Mecklenburg County
Health Department

Re: New Subdivision/Moore's Chapel Road
File: 3296B
Parcel: 053-174-05 & 053-174-07

MECKLENBURG COUNTY HEALTH DEPARTMENT
SITE EVALUATION REPORT
SERIAL NUMBER 20547

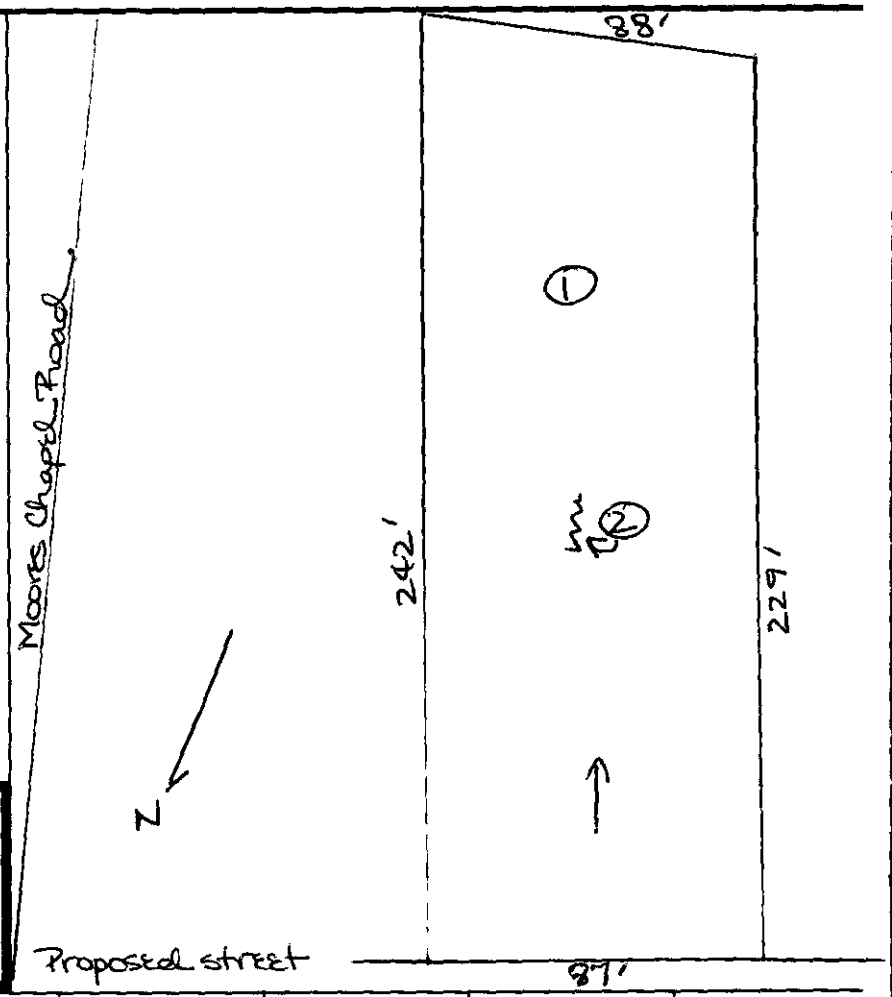
Comments: 100% repair, .3 gal/ft2/day
LTAR

FACTORS	AREA 1	AREA 2	AREA 3	AREA 4	AREA 5	AREA 6
Topography	(S) PS U 2-10%	S PS (U) slight depression	S PS U	S PS U	S PS U	S PS U
Texture slightly expansive clay	S (PS) U	S PS U —	S PS U	S PS U	S PS U	S PS U
Structure	S (PS) U Blocky	S PS U —	S PS U	S PS U	S PS U	S PS U
Drainage >48" to soil Wetness	(S) PS U	S PS U —	S PS U	S PS U	S PS U	S PS U
Depth	S (PS) U >45"	S PS U —	S PS U	S PS U	S PS U	S PS U
Restrictive Horizons	(S) PS U >48"	S PS U —	S PS U	S PS U	S PS U	S PS U
Available Space	S PS (U) Restricted	S PS U —	S PS U	S PS U	S PS U	S PS U
Other (specify)	S PS U	S PS U —	S PS U	S PS U	S PS U	S PS U
Soil Group/Series	IV cecil-like	slight depression				
Area Classification	S PS (U)	S PS (U)	S PS U	S PS U	S PS U	S PS U

PROPOSED PLOT PLAN

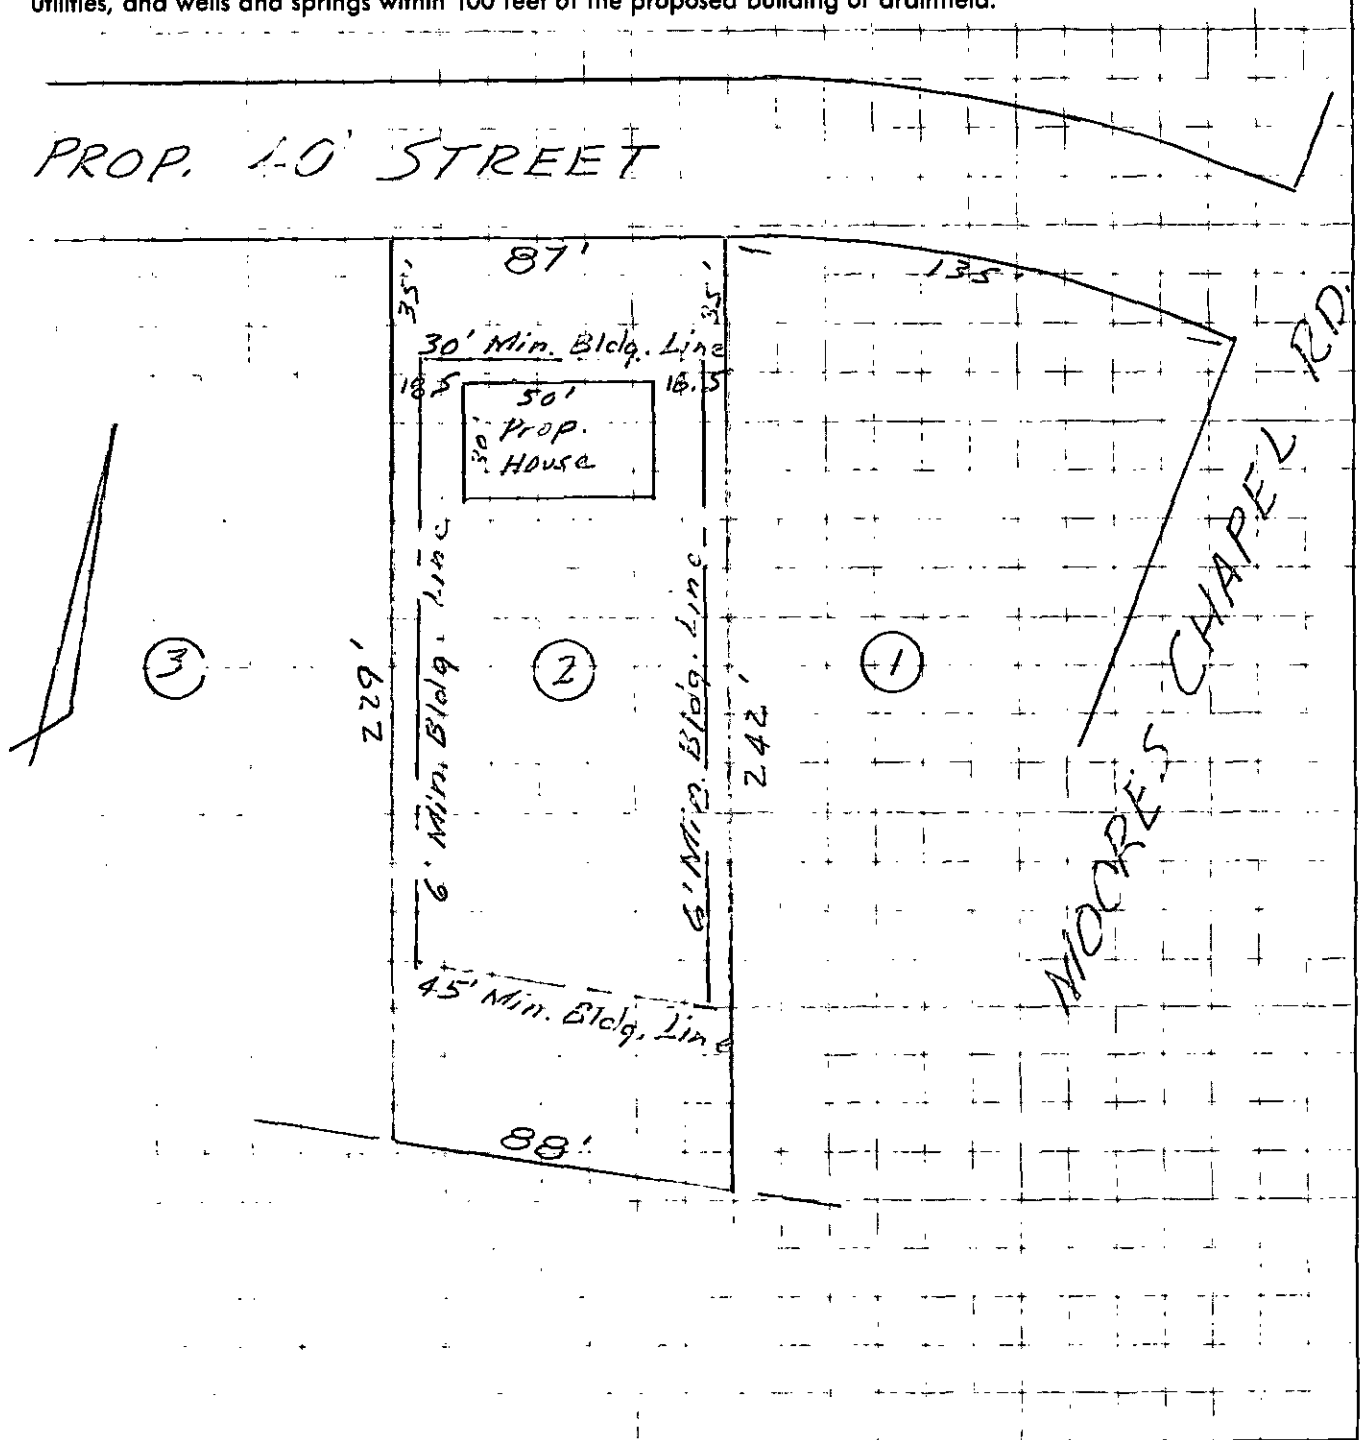
Receipt of the plans and specifications for a conventional system of sewage disposal for the above property is hereby acknowledged. Upon receipt of the information, a review was made of the material on file and a site evaluation was conducted. The plan was then reviewed in conjunction with provisions of 15 NCAC 18A, .2900. "Laws and Rules for Sanitary Sewage Collection, Treatment and Disposal". Our comments are listed below:

.1945 AVAILABLE SPACE
(a) Sites shall have sufficient available space to permit the installation and proper functioning of ground absorption sewage treatment and disposal systems, based upon the square footage of nitrification field required for the application rate determined in accordance with these Rules.
(b) Sites shall have sufficient available space for a repair area equal to the area determined in Rule .1945 (a) of this Section.

For these reasons, the plans as submitted are disapproved: However, state regulations provide that sites originally classified unsuitable may be utilized for the installation of alternate or modified sewage disposal systems provided the requirements of 15 NCAC 18A .1948 (c) are met.

Possible ways to develop this site includes submittal of a plan for a Prefabricated, Permeable Block Panel System (PPBPS). This plan would also need to include meeting all off-set requirements for the house, house site and meet separation distance requirements for a well from a septic system (minimum 50' separation). Enclosed is a copy of Rule .1956 Modifications to Septic Tank Systems pertaining to PPBP Systems.

Should you desire to file for permission to install an alternate or modified sewage treatment system on the property, please submit an Application For An Improvement Permit with an ACCURATELY dimensioned plot plan detailing the location of current and/or proposed buildings, wells and sewage disposal systems to this office. They will be reviewed, and if it is determined that the proposed system may reasonably be expected to function satisfactorily, an Improvement Permit will be issued by the Department upon completion by you, of a formal request for lot reclassification.
